Access Compliance Report Public Rights-of-Way (Curb Ramps)

Intersection ID: 20684 Main Street: PARK_SOUTH_DR **Cross Street: STOKES AV** Location: NE **ADA ID: 7CE5A9AF7140** Ramp Type: PerpDiag Initial Pass/Fail: Fail **Overall Compliance: No** Severity Score: 31.25

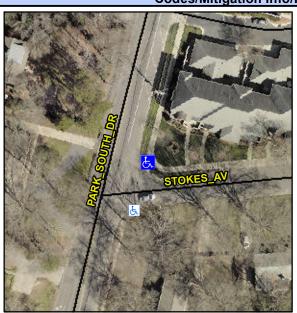
Street 1 Name Stop Condition-Street 2 Street 2 Name Stop Condition-Street 1 PARK SOUTH DR None STOKES AV StopSign Possible Solutions: Remove & Replace Curb Ramp With **Two New Directional Ramps or** Equivalent. Surveyor Notes: N/A PROW/ADA: Not Found, R304.5.1, R304.2.2, R304.5.3

Field Measurements/Component Compliance					
Compliance Description		Data	Comp	liance Description	Data
N/A	Ramp Length (in)	85.0	No	Ramp Slope (%)	8.9
No	Ramp Width (in)	33.0	No	Ramp XSlope (%)	3.1
N/A	Flare Type LT	N/A	N/A	Flare Type RT	N/A
N/A	Flare Slope LT (%)	N/A	N/A	Flare Slope RT (%)	N/A
N/A	Flare Traversable LT?	N/A	N/A	Flare Traversable RT?	N/A
N/A	Landing Length (in)	N/A	N/A	DWS Provided?	N/A
N/A	Landing Width (in)	N/A	N/A	DWS Contrast?	N/A
N/A	Landing Slope (%)	N/A	N/A	DWS Length (in)	N/A
N/A	Landing X Slope (%)	N/A	N/A	DWS Full Width?	N/A
N/A	Landing Curb? (Y/N)	N/A	N/A	DWS Offset (in)	N/A
N/A	Shared Landing?	N/A			
N/A	Gutter Ponding?	N/A	N/A	Gutter Slope (%)	N/A
N/A	Gutter Lip Ht (in)	N/A	N/A	Gutter X Slope (%)	N/A
N/A	Painted X Walk1?	No	N/A	Painted X Walk2?	No
	X Walk 1 Direction	To W		X Walk 2 Direction	To SW
N/A	X Walk 1 Width (in)	N/A	N/A	X Walk 2 Width (in)	N/A
	X Walk 1 Slope (%)	2.2		X Walk 2 Slope (%)	1.7
